SB-10057499-2967

Repair Notice

10141

Missing Allison Transmission Oil Level Sensor Wire on Model 579/567

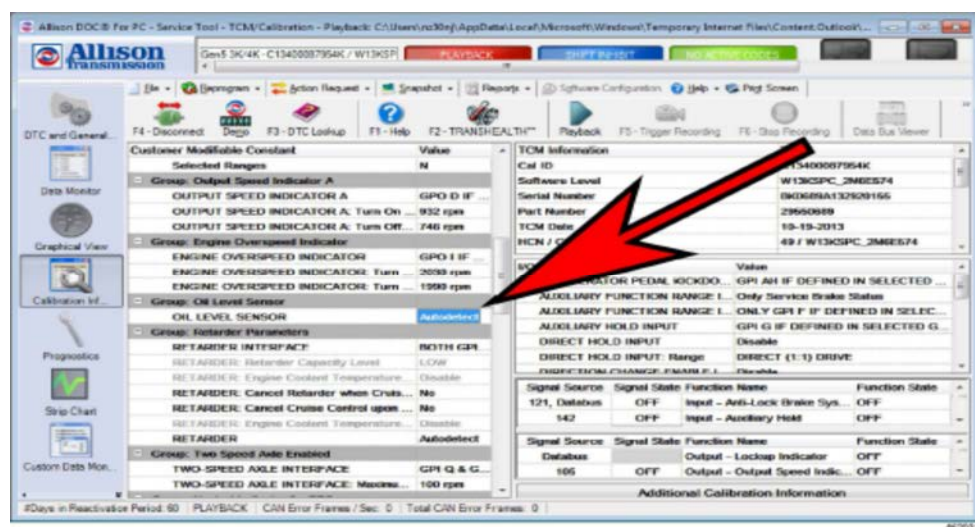
The Peterbilt models listed above have been built without a wire for the oil level sensor (OLS) in a portion of the OEM harness. Wire 116 may be present from the transmission to a bulkhead connector, but it may be missing on the other side of the bulkhead.

The symptoms of the missing wire are:

- Inability to check oil level using the Pushbutton Shift Selector (skips to Prognostics).
- Very low (e.g. - 6.0 Quarts) or no oil reading for "Oil Level Deviation" in the Data Monitor tab of the Universal Allison DOC ® service tool.

NOTE: When viewing the Calibration Information screen in the Universal Allison DOC ® service tool software, the "Oil Level Sensor" parameter will still show "Autodetect."
